SERVICE INFORMATION LETTER SIL0124 August 2, 2024 rev 1

Regular Check and Overhaul Flow Diagram Correction

Figure 1 Utilize the Regular Check flow diagram from the Saft OMM 24-30-99 Feb 14/2024 for corrections ① and ②.

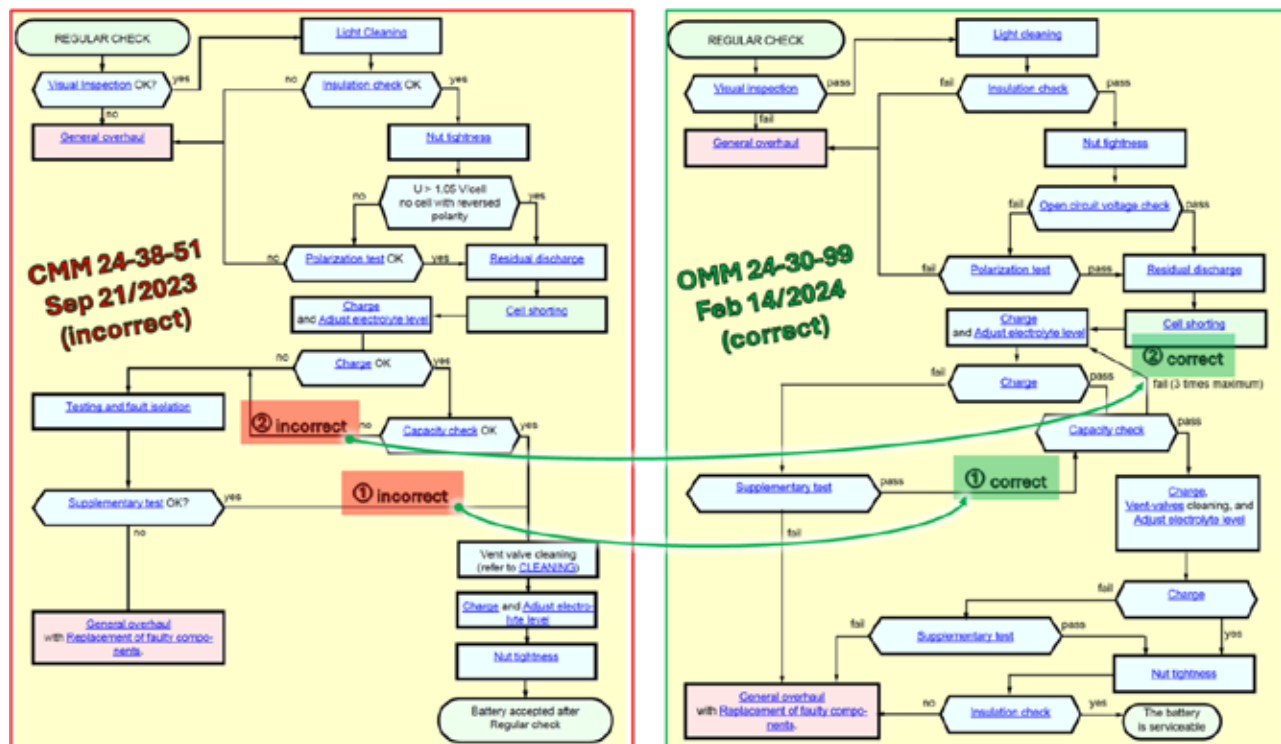
A correction to the Regular Check flow diagram in CMM 24-38-51 is pending. The flowchart, in Chapter 7, should direct the technician back to the Capacity Check after a successful Supplementary Test. It incorrectly directs the technician to conduct a Vent valve cleaning following a successful Supplementary Test. Additionally, the Regular Check flow diagrams in CMM 24-38-51, CMM 24-31-20 and CMM 24-31-15 does not give an option to loop back to charge from a failed capacity test for up to 3 times.

Table 1 Apply the following corrections to the Regular Check flowchart

For battery type	utilize the OMM Regular Check flow diagram and
2758,	apply correction ① and ②
1658-6,	apply correction ②
4078-2 / 40678-2,	apply correction ②

As the CMM updates are pending, utilize the Regular Check flow diagram from the OMM 24-30-99 Feb 14/2024 in the interim. See Table 1 and Figure 1 for Regular Check and Table 2 and Figure 2 for Overhaul.
